Access Compliance Report

Public Rights-of-Way

(Curb Ramps)

Intersection ID: 9123	Main Street: ROZZELLES_FERRY_RD	Cross Street: CORONET_WY	Location: S
ADA ID: 575E09124856	Ramp Type: Perp	Initial Pass/Fail: Fail	Overall Compliance: No
Severity Score: 22.5			
Codes/Mitigation Info/Possible Solution		Field Measurements/Component Compliance

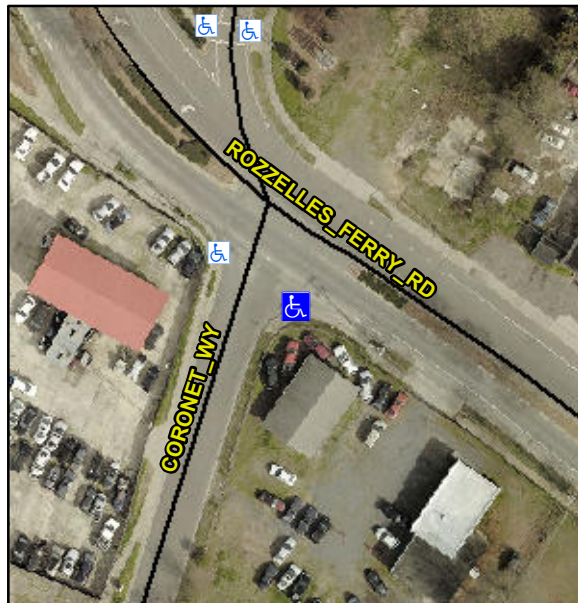
Not Found, R304.5.1, R304.2.2, R304.5.3

Compliance	Description	Data	Compliance	Description	Data
N/A	Ramp Length (in)	70.0	No	Ramp Slope (%)	8.5
No	Ramp Width (in)	47.5	No	Ramp XSlope (%)	2.1
N/A	Flare Type LT	N/A	N/A	Flare Type RT	N/A
N/A	Flare Slope LT (%)	N/A	N/A	Flare Slope RT (%)	N/A
N/A	Flare Traversable LT?	N/A	N/A	Flare Traversable RT?	N/A
N/A	Landing Length (in)	N/A	N/A	DWS Provided?	N/A
N/A	Landing Width (in)	N/A	N/A	DWS Contrast?	N/A
N/A	Landing Slope (%)	N/A	N/A	DWS Length (in)	N/A
N/A	Landing X Slope (%)	N/A	N/A	DWS Full Width?	N/A
N/A	Landing Curb? (Y/N)	N/A	N/A	DWS Offset (in)	N/A
N/A	Shared Landing?	N/A			
N/A	Gutter Ponding?	Yes	N/A	Gutter Slope (%)	N/A
N/A	Gutter Lip Ht (in)	N/A	N/A	Gutter X Slope (%)	N/A
N/A	Painted X Walk1?	No	N/A	Painted X Walk2?	N/A
	X Walk 1 Direction	To NW		X Walk 2 Direction	N/A
N/A	X Walk 1 Width (in)	N/A	N/A	X Walk 2 Width (in)	N/A
	X Walk 1 Slope (%)	2.2		X Walk 2 Slope (%)	N/A
	X Walk 1 X Slope (%)	2.8		X Walk 2 X Slope (%)	N/A

Remove & Replace Entire Ramp.
